## **Preesall Underground Gas Storage Facility, Lancashire**

### **Re-determination of Application for Development Consent Order**

#### **Senergy (GB) Ltd Response to Issues raised related to their Independent Geological Assessment of the Proposed Preesall Gas Storage Site**

**29<sup>th</sup> October 2014**

**Figures 1a and 1b: Selection of Error Range in Base Salt depth conversion**

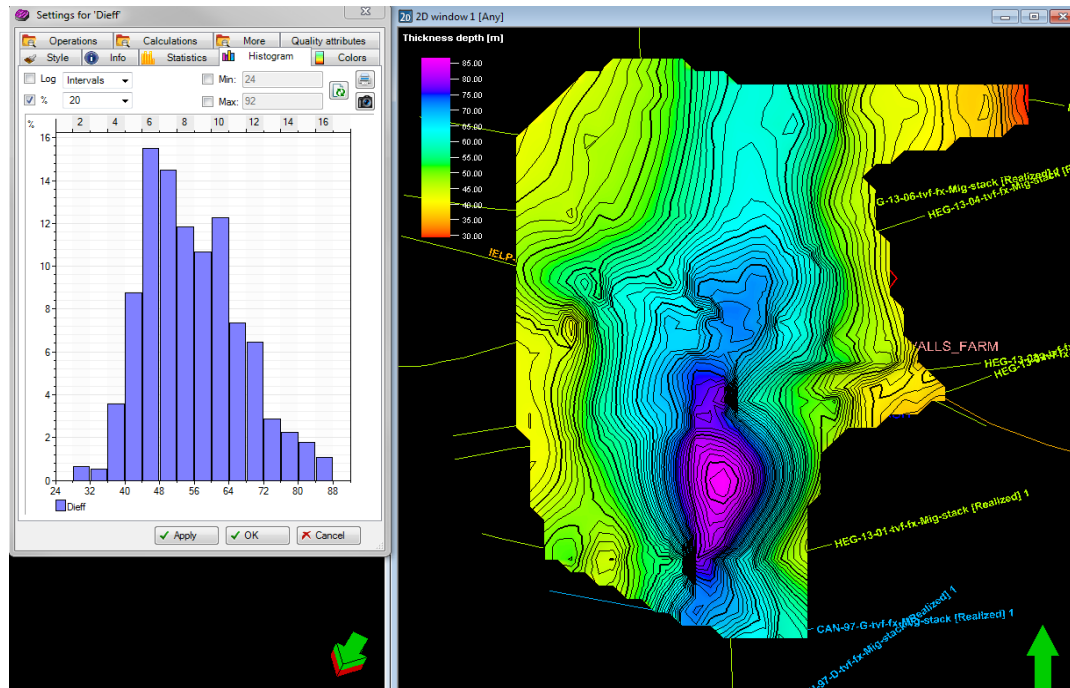
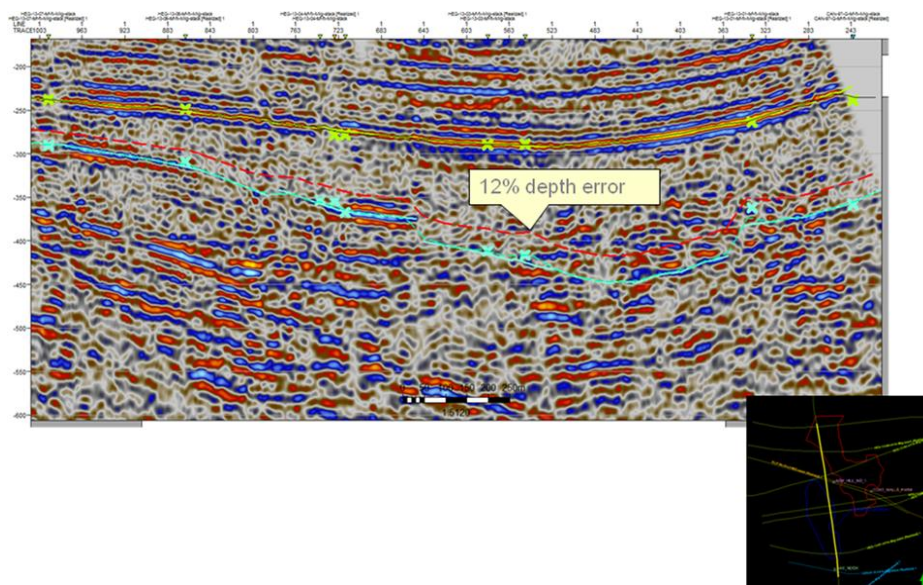
**Senergy Error Range for Base Salt pick:** Halite note (Geological Technical Appendix, section 2.1.8) that Senergy applied an error margin of 0% (at well ties) -12% (at the deepest part of the basin) to the Base Salt depth conversion but it is unclear how this was applied in the geological Assessment.

**Error Range on Base Salt pick:** Senergy estimated the error in the depth conversion at the Base Salt pick as between 0% for areas close to well ties up to 12% plus or minus for areas away from well ties. Generally this equated to a 0% error at the margins of the basin to 12% at the deepest part of the basin which is mostly in the Western part of the area.

An image showing how this error range was estimated is shown on **Figures 1a and 1b** below.

Based on this analysis Senergy considered how this uncertainty should be included in the Monte Carlo analysis and decided that a reasonable approach would be to use a  $\pm 12\%$  uncertainty at the deepest BGS Base Salt pick and a zero uncertainty at the shallowest BGS Base Salt pick. The uncertainty at depths in between would be interpreted linearly. Based on the 19 cavern locations the shallowest Base Salt pick is 418 m below ground (cavern 1) and the deepest is 715 m (cavern 18).
